DEPARTMENT OF DEVELOPMENT SERVICES – PLANNING DIVISION
REPORT: 81-83 Hungerford Street Hartford, CT 06106
For consideration: September 16, 2020

STAFF REPORT

PROJECT: 81-86 Hungerford Street
PARCEL ID: 225-433-044

CITY OF HARTFORD
HISTORIC PRESERVATION COMMISSION RESOLUTION
81 HUNGERFORD STREET
HISTORIC PRESERVATION PROPOSAL

View of 81 Hungerford porch, Google street view June 2019

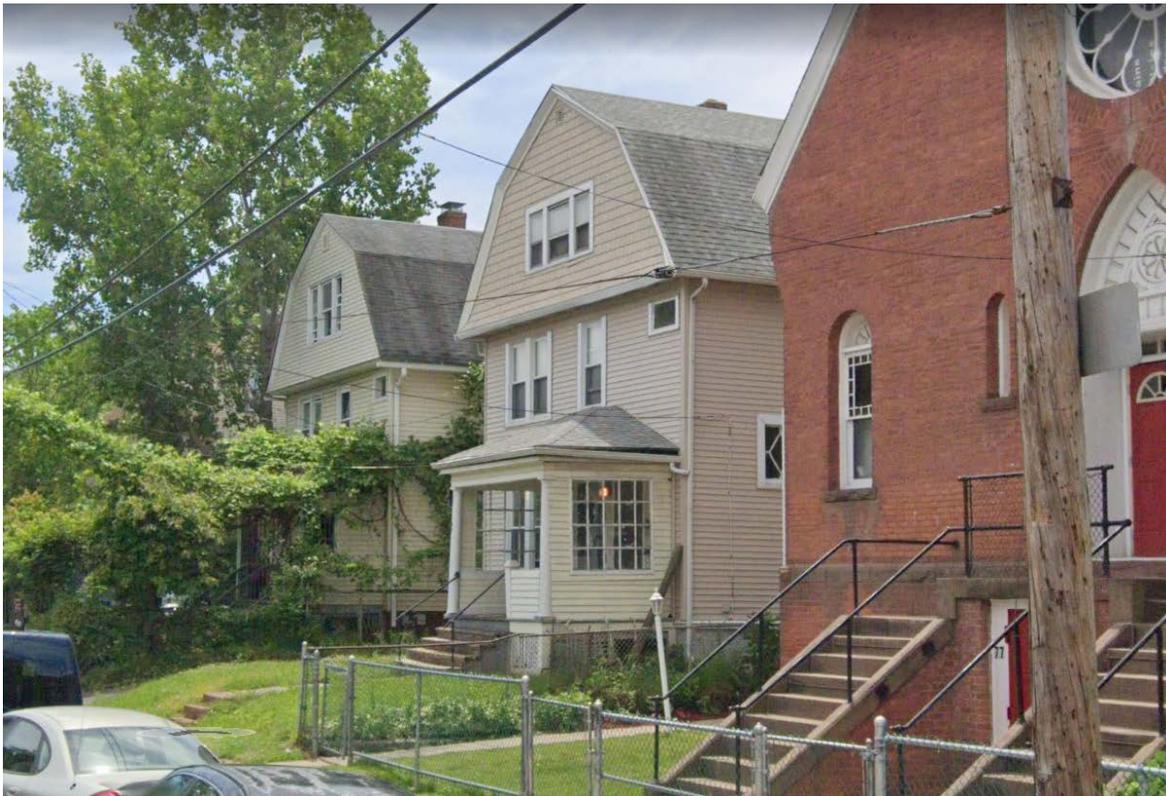
Staff does not believe that repairing the existing porch and stairs will negatively impact the historic character of the neighborhood, which is largely characterized by working class multi-family homes of the late 19th and early 20th century with various façade and porch modifications. This house is not representative of the Greek Revival, Italianate, Traditional Perfect Six, or three-decker styles that characterize the Frog Hollow Historic District and are noted in the district nomination. The siding is not original and the front porch was not originally enclosed.

Staff believes the desired repairs to damaged and rotting wood can be made but that the porch should not be re-enclosed with new siding and vinyl windows. Rather, the proposed work is an opportunity to restore some historic character to this building by leaving the porch open and restoring the original railings. Railings used on the stair should be wood to match the remaining porch railings as closely as possible. Porch columns should remain intact and be repaired as needed. If an enclosed porch is desired, it should be done with divided glass behind the columns and railing per the *Guidelines for Renovations and Additions to Historic Buildings*.

1. Pressure treated lumber shall not be used to replace existing porch elements;
2. The vinyl siding and windows enclosing the porch shall not be replaced but rather completely removed and replaced with the original restored railings or enclosed with divided glass behind the columns and railing per the *Guidelines for Renovations and Additions to Historic Buildings*.
3. Wherever columns or railings cannot be repaired in place or salvaged for re-use and are in need of replacement, these components shall be replaced to match as closely as possible the material, dimensions, and profiles of existing components, including round balusters for wood railings.
